**From:** Miquel Garcia <Miquel.Garcia@hrsservices.co.uk>  
**Sent:** 08 October 2018 11:54  
**To:** Stephen Pokora  
**Subject:** RE: Leybourne Village Hall - HRS job ref.127119 SBEM/EPC preliminary results  
**Attachments:** Leybourne Village Hall\_AS-DESIGN DRAFT BRUKL v02.pdf; 127119\_Leybourne Village Hall West Malling\_Energy Model Tracker v02.pdf

**From:** Miquel Garcia  
**Sent:** 02 October 2018 17:51  
**To:** 'Stephen Pokora'  
**Subject:** RE: Leybourne Village Hall - HRS job ref.127119 SBEM/EPC preliminary results

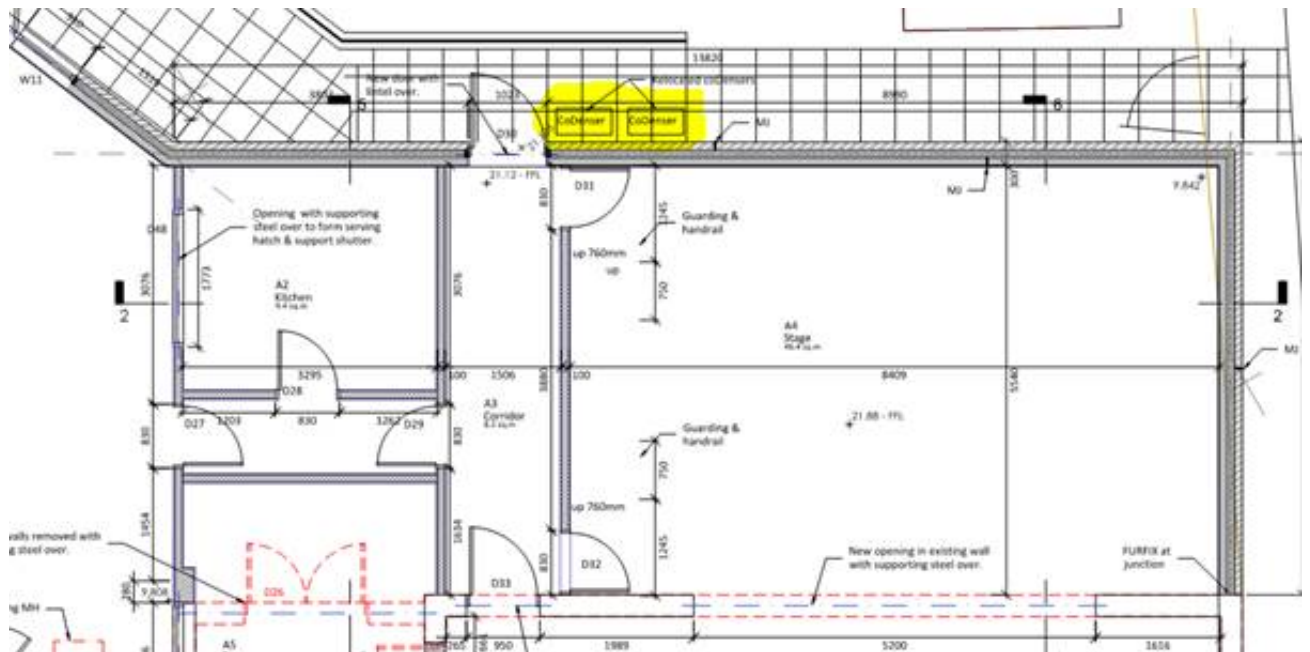
I have run several simulations with different scenarios. At the moment, the new extension fails to achieve the minimum Part L compliance 'pass' by a short margin. The BER (actual building CO2 emissions rate) is slightly higher than the TER (target CO2 emissions rate). Please find attached the provisional BRUKL report and a pdf with a summary of all the building specifications used.

Part L2 (2010) - England/Wales - Analysis		Results
Building Emissions Rate (BER)	23.0	kg.CO2 / m2
Notional building Emissions Rate	22.6	kg.CO2 / m2
Target Emissions Rate (TER)	22.6	kg.CO2 / m2
		Did the analysis pass the CO2 emissions rating?
		NO

The initial results prove that:

1. **External walls.** It will be difficult to achieve the minimum Part L compliance 'pass' using Rockwool 100mm (0.29 W/m2k), so the Kingspan K106 100mm is recommended (U-value 0.17 W/m2k).
2. **Air permeability.** I have inputted default 15 m3/m2.h @50 Pa. From above results, I believe an air test will not be necessary.
3. **Combi gas boiler.** To reduce at maximum the CO2 emissions associated to the heating demand, I had to use a gas boiler with 91% efficiency
4. **Lighting efficacy.** 60Lm/W shows to be insufficient so I have used 80LmW instead (note: current LED lamps usually achieve that efficacy)
5. **Air conditioning.** Assumed none. However, does the floor plan show 2No. external condenser units relocated in the back of the building?

6. **Mechanical Ventilation.** As per my previous e-mail but I have omitted the local extract fan in the Bar room.

7. **Renewables.** I don't think it will necessary to install any PV panel to comply with Part L.
